# MPC5125 (M01S) Errata

This document identifies implementation differences between the MPC5125, M01S (Rev. 1), and the processor's description contained in the *MPC5125 Microcontroller Reference Manual* and the *MPC5125 Microcontroller Data Sheet*. Refer to <http://www.freescale.com> for the latest updates.

Figure 1.  $V_{\text{BAT\_RTC}}$  to  $V_{\text{DD\_CORE}}$  Timing

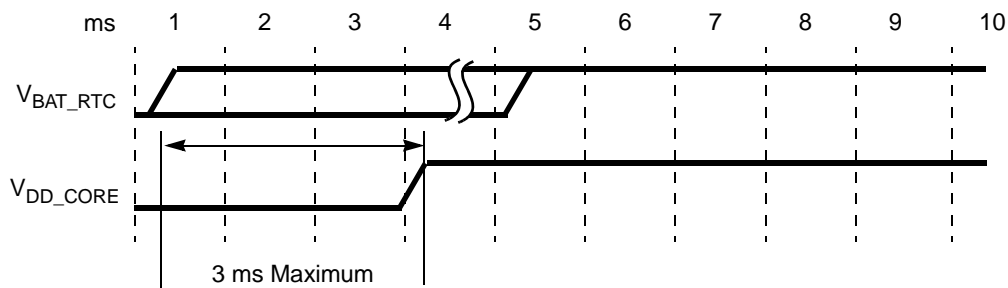
The Real-Time Clock (RTC) oscillator may not start properly when the  $V_{\text{BAT\_RTC}}$  power domain is active and  $V_{\text{DD\_CORE}}$  is transitioning from power-off to power-on.

When the  $V_{\text{BAT\_RTC}}$  power domain is active and the  $V_{\text{DD\_CORE}}$  transitions from off to on, the RTC time base becomes unreliable. The functionality of the oscillator and clock feeding the RTC counter is in one of three states:

Ensure that the  $V_{\text{BAT\_RTC}}$  power domain does not lead the  $V_{\text{DD\_CORE}}$  by more than 3 ms, or toggle  $V_{\text{BAT\_RTC}}$  after  $V_{\text{DD\_CORE}}$  has been turned on. The 3 ms is measured from  $V_{\text{BAT\_RTC}}$  at 50% to  $V_{\text{DD\_CORE}}$  at 90% of full values.

$V_{BAT\_RTC}$  can be powered concurrently with or enabled by  $V_{DD\_CORE}$ . Cycling  $V_{BAT\_RTC}$  power will result in the RTC counter being reset. See item 4 below. Following this workaround measure eliminates the need for measures 2 and 3 below.
